Access Compliance Report

Public Rights-of-Way

(Curb Ramps)

Intersection ID: 21297	Main Street: STARBROOK_DR	Cross Street: WRENTREE_DR	Location: NW
ADA ID: 06398F91EF0F	Ramp Type: PerpDiag	Initial Pass/Fail: Fail	Overall Compliance: No
		Severity Score: 8.75

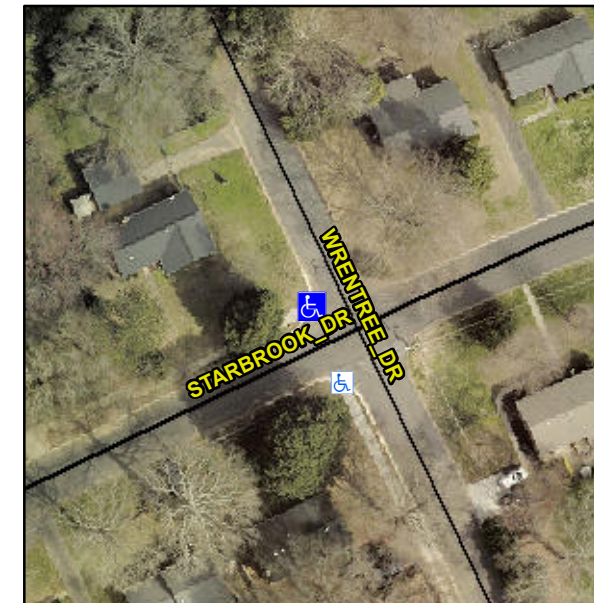
Not Found, R304.5.1

Compliance	Description	Data	Compliance	Description	Data
N/A	Ramp Length (in)	58.0	Yes	Ramp Slope (%)	6.0
No	Ramp Width (in)	47.0	Yes	Ramp XSlope (%)	1.1
N/A	Flare Type LT	N/A	N/A	Flare Type RT	N/A
N/A	Flare Slope LT (%)	N/A	N/A	Flare Slope RT (%)	N/A
N/A	Flare Traversable LT?	N/A	N/A	Flare Traversable RT?	N/A
N/A	Landing Length (in)	N/A	N/A	DWS Provided?	N/A
N/A	Landing Width (in)	N/A	N/A	DWS Contrast?	N/A
N/A	Landing Slope (%)	N/A	N/A	DWS Length (in)	N/A
N/A	Landing X Slope (%)	N/A	N/A	DWS Full Width?	N/A
N/A	Landing Curb? (Y/N)	N/A	N/A	DWS Offset (in)	N/A
N/A	Shared Landing?	N/A			
N/A	Gutter Ponding?	N/A	N/A	Gutter Slope (%)	N/A
N/A	Gutter Lip Ht (in)	N/A	N/A	Gutter X Slope (%)	N/A
N/A	Painted X Walk1?	No	N/A	Painted X Walk2?	No
	X Walk 1 Direction	To S		X Walk 2 Direction	To E
N/A	X Walk 1 Width (in)	N/A	N/A	X Walk 2 Width (in)	N/A
	X Walk 1 Slope (%)	3.7		X Walk 2 Slope (%)	0.9
	X Walk 1 X Slope (%)	0.8		X Walk 2 X Slope (%)	3.7

Remove & Replace Curb Ramp With Two New Directional Ramps or Equivalent.
